Access Compliance Report Public Rights-of-Way (Curb Ramps)

Main Street: N_SHERI_ST Cross Street: BIXBY_AVE Location: NW

ADA ID: RPAT210924123640 Ramp Type: Type 6 - Directional 1 Initial Pass/Fail: Fail Overall Compliance: No Severity Score: 30

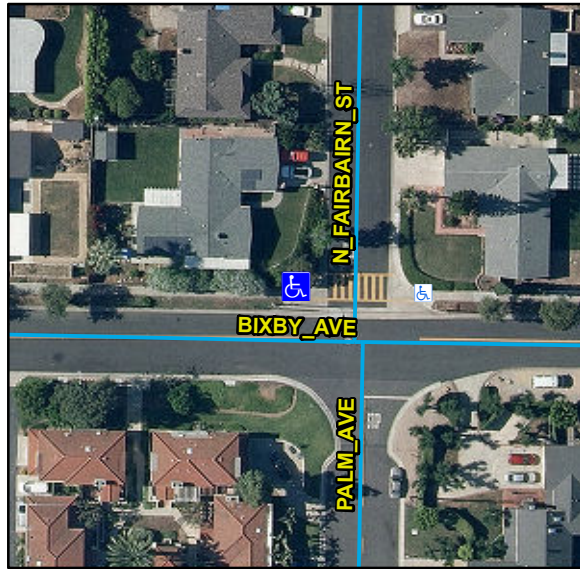
Compliance	Description	Data	Compliance	Description	Data
N/A	Ramp Length (in)	104	N/A	Flare Type LT	
Yes	Ramp Width (in)	59			N/A
No	Ramp Run Slope (%)	8.9	N/A	Flare Slope LT (%)	N/A
No	Ramp Cross Slope (%)	5.6	N/A	Flare Traversable LT	N/A
N/A	Grade Break	N/A	N/A	Flare Type RT	
N/A	Grade Break Slope (%)	N/A			N/A
N/A	Grade Break Cross Slope (%)	N/A	N/A	Flare Slope RT (%)	N/A
	Addl Para Ramp Left?	No	N/A	Flare Traversable RT	N/A
	Addl Para Ramp Right?	No	N/A	DWS Provided	N/A
N/A	Landing Present	N/A	N/A	DWS Contrast	N/A
N/A	Landing Length (in)	N/A	N/A	DWS Length (in)	N/A
N/A	Landing Width (in)	N/A	N/A	DWS Full Width	N/A
N/A	Landing Run Slope (%)	N/A		DWS Offset Type	N/A
N/A	Landing Cross Slope (%)	N/A	N/A	DWS Left Offset (in)	N/A
N/A	Landing Movement Obstructed?	N/A	N/A	DWS Right Offset (in)	N/A
	Landing Movement Type	N/A			
N/A	Landing Shared	N/A			
N/A	Marked Crosswalk 1	Yes	N/A	Clear Space	N/A
	Crossing 1 Direction	E	N/A	Clear Space To Crosswalk (in)	N/A

Marked Crosswalk 1 Width (in)	120			
N/A	Ramp Inside Crosswalk 1	No			
	Crossing 1 Slope (%)	2.8			
	Crossing 1 Cross Slope (%)	5.5			
N/A	Gutter Ponding	N/A	N/A	Curb Slope	7.6
Yes	Gutter Lip Height (in)	0		Road Run Slope (%)	N/A
N/A	Gutter Run Slope (%)	N/A		Road Cross Slope (%)	N/A
N/A	Gutter Cross Slope (%)	N/A		Parallel Ramp Side	N/A
Yes	Overall Surface Condition	Acceptable	No	Perp Joint Present	No
	Cross Gutter Present?	Yes		Spandrel Present?	Yes
	Replace Cross Gutter?	No		Replace Spandrel?	No

Remove & Replace Entire Ramp. Restripe Crosswalk.
